Access Compliance Report

Public Rights-of-Way

(Curb Ramps)

Intersection ID: 52442	Main Street: WOODWARD_AV	Cross Street: BENDING_BIRCH_PL	Location: W
ADA ID: 7254372C82A8	Ramp Type: Directional1	Initial Pass/Fail: Fail	Overall Compliance: No
			Severity Score: 13.75

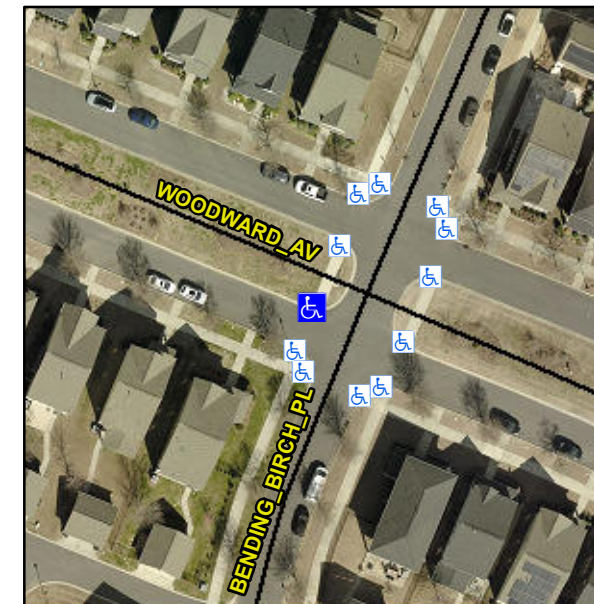
Surveyor Notes:

LOCATED ON MEDIAN

PROW/ADA:

R304.2.2

Possible Solutions:

Remove & Replace Entire Ramp.
